HORSHAM DISTRICT COUNCIL CONSULTATION

TO:	Horsham District Council – Planning Dept
LOCATION:	Berkeley Homes Development Site Phase 4 and 5 Worthing Road Southwater West Sussex
DESCRIPTION:	Minor Material Amendment (Section 73) to vary condition 2 of application reference DC/24/0772 (non material amendment to previously approved application DC/18/1246) to The development hereby approved comprises 199 no. residential dwellings including 61 affordable dwellings and vary the plans approved under condition 1 of application reference DC/18/1246.
REFERENCE:	DC/24/1158
RECOMMENDATION:	Advice / Modification / More information
SUMMARY OF COMMENTS & RECOMMENDATION: Please see comments below in regard to the proposed layout changes and implications to the landscape strategy.	
MAIN COMMENTS: <u>Layout</u> 1. We note encroachment within the RPA of T130 and T132, which is likely to affect the trees' integrity by creating a poor relationship between the existing trees and new housing development, placing future pressure for lopping or felling. Given the undeveloped nature of the site the proposed layout should seek to retain and protect the existing trees recognising their landscape value within

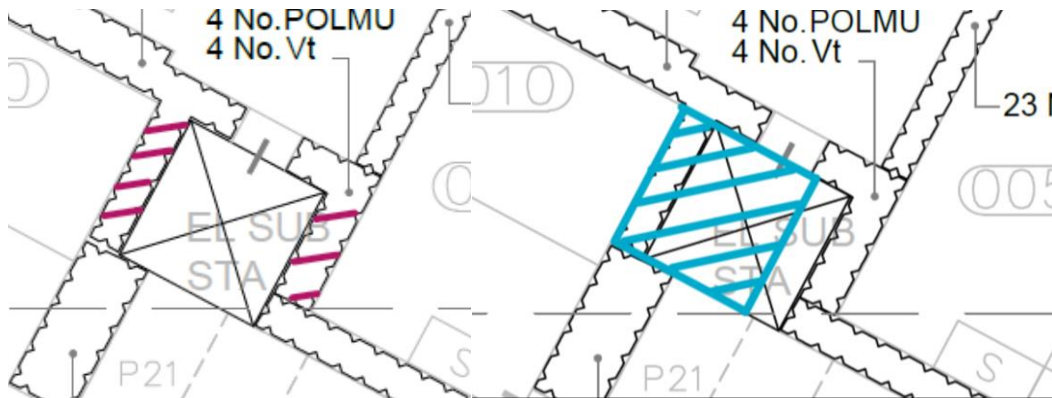
6. We note the gradient and basin depth south of plots P141-143 may require fencing and/or planting as a deterrent. Please amend as necessary.
7. Please note that we expect to see updated drawings, levels and planting for the attenuation basins and any further proposed SuDS proposals based on recommendations made below.
